Supplemental Response to Town of Los Gatos' Consulting Architect's letter dated March 29, 2019

**15925 Quail Hill Drive
Architecture and Site Application S-19-012**

**Prepared by: Tom Sloan AIA
Metro Design Group**

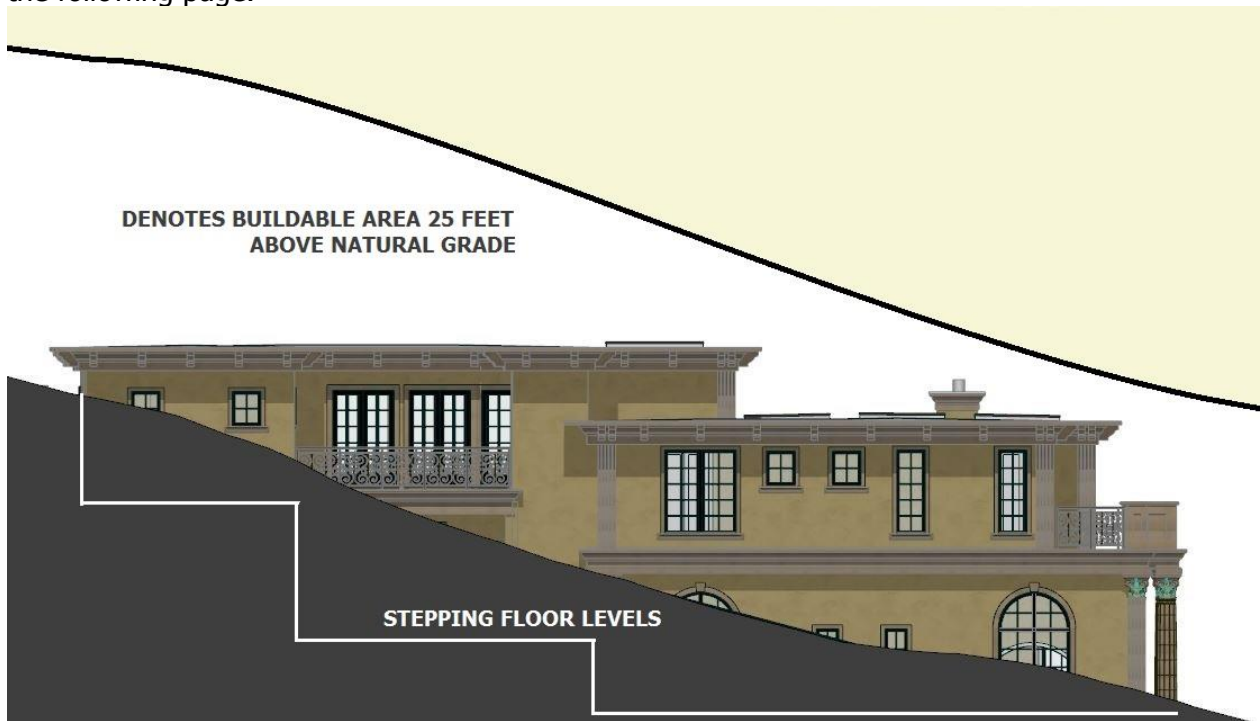
1.) Buildings shall be designed to minimize bulk, mass and volume so as not to be prominently visible from a distance or from surrounding properties.

Due to the slope of site and the narrow lot width, a large portion of residence is located partially or wholly below the grade. As viewed from above the site, the visible walls that facing uphill area less than 5 feet above the surrounding natural grade. The principal façade facing downhill is 17 feet above the adjacent grade. The building massing steps uphill while providing an interior volumes that meets the owner's objectives and goals. The massing is also broken up into simple segments that reduce the overall appearance of mass and bulk. New trees will be strategically planted to mitigate any and all visual impacts that the new building might otherwise create.
